MODIFICATION REQUEST:

Garvan St Vincent's Campus Cancer Centre, Darlinghurst

MP 09_0011 MOD 1 – Modifications to building alignment; northern façade signage and ground floor tenancy use

Director-General's
Environmental Assessment Report
Section 75W of the
Environmental Planning and Assessment Act 1979

Figure 2: Proposed illumination of the Kinghorn Cancer Centre sign

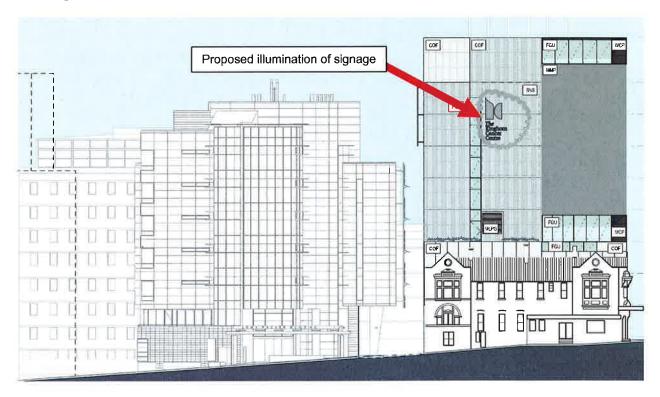
The proposal seeks to modify an existing approved sign by illuminating the 'Kinghorn Cancer Centre' logo on the Kinghorn Cancer Centre northern façade. The signage is to be illuminated at night by two 440 watt spot lights, which will shine from either side of the sign from level 6 below, as shown in **Figure 2**. The signage is to be constructed from steel plate with a matt finish to limit glare.

Council indicated that any signage should not be too bright or flash and should not result in light spill beyond the signage. The proponent indicated that a light analysis has been undertaken showing light spillage to be at an acceptable level, particularly as the light is angled away from residential development.

On this basis, the Department considers that the proposed signage modification is acceptable given that:

- the signage will be orientated away from residential developments;
- the signage will be constructed from steel plate logo with matt finish to limit glare; and
- the signage is consistent with the objectives of AS4282-1997 and State Environmental Planning Policy No. 64 Advertising and Signage.

Figure 3: Location of the proposed café within the Kinghorn Cancer Centre

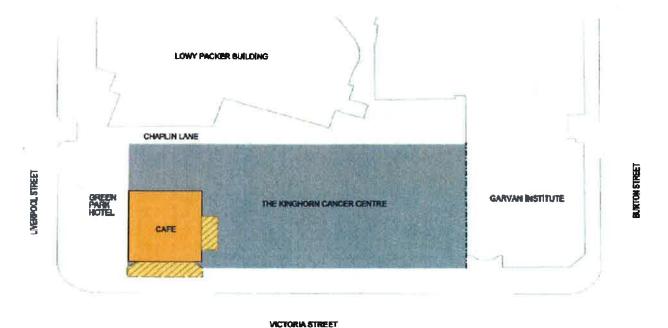
Council have recommended that measures be implemented to ensure the premise is used solely as a café and restrict any changes to this use. The proponent has indicated that the application is for a café, therefore the Department will assess the merits of this application based on this provision.

Council noted that the proposal does not provide for mechanical cooking exhaust, therefore no food should be cooked on site. The proponent indicated that food items sold on site will not be prepared at the premise.

Therefore, the Department is satisfied that the proposed use of the ground floor tenancy is consistent with the original project approval.

Figure 4: Victoria Street Elevation of proposed cafe

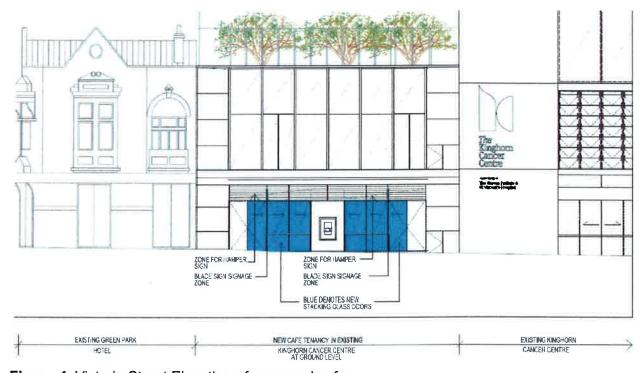
The modification also seeks to install folding doors at the tenancy entrance, as shown in **Figure 4**. Council raised concerns over the proposed glass sliding doors for the café and whether the noise generated from opening of the doors will impact on the local amenity. The proponent revealed that many uses along Victoria Street operate with their doors open to allow for street activation. The proponent has also acknowledged that doors are not to remain open after 10pm Monday to Sunday. The café will not generate unacceptable acoustic impacts on the locality, particularly when viewed in context with the surrounding late night trading establishments.

On this basis, the Department considers that the proposed modification will not produce adverse impacts on amenity given that:

- the premise is located in close proximity to other late night uses;
- extended trading hours are subject to a 1 year trial period to allow for ongoing monitoring;
 and
- the opening and closing of doors is consistent with the objectives of City of Sydney's Late Night Development Control Plan.
